BEFORE THE ATOMIC SAFETY AND LICENSING BOARD

In the Matter of)
)
U.S. ARMY) Docket No. 40-8838-MLA
)
(Jefferson Proving Ground Site))

PREFILED TESTIMONY OF JON M. PECKENPAUGH

Figure 1. Schematic Cross Section Through Big Creek Valley Within DU Impact Area Near Cave BC-12.

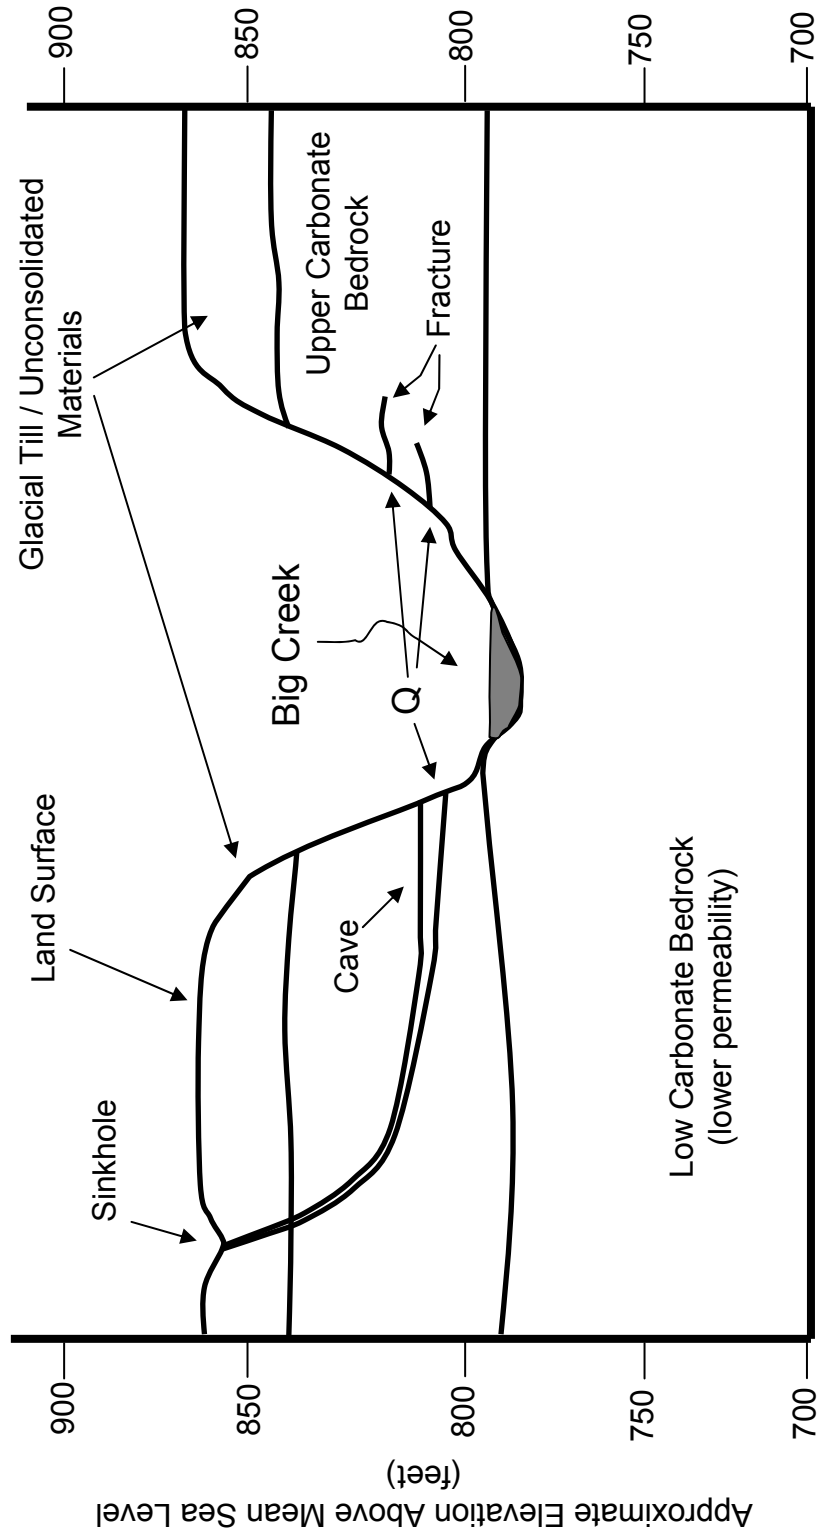
16 Big Creek and Middle Fork Creek are the base levels for the karst system which have
17 developed in the upper carbonate bedrock within the DU Impact Area. The karst system (that
18 is, the caves and springs) at this site has discharge points and in some cases for a limited time
19 period, inflow points above the current Big Creek and Middle Fork Creek stream beds. A review
20 of the cave study at this site indicates that there are no lower cave segments below the upper
21 carbonate bedrock. Karst Study at 43 - 44. This karst system lies approximately 5 to 10 feet
22 above the creek beds. There do not appear to be any major karst features below the upper
23 carbonate bedrock. This does not preclude fractures in the bedrock that the creek beds lie
24 upon, which would allow stream flow or groundwater to flow between each other. Therefore, I
25 believe that many of Mr. Norris' statements pertaining to the karst system at the DU Impact Area

1 are not representative of actual site conditions. See "Attachment B" which is a diagram
2 depicting a schematic cross section through Big Creek Valley within the DU Impact Area. This
3 diagram provides a general representation of the relationship of the primary karst system, the
4 caves, and Big Creek.
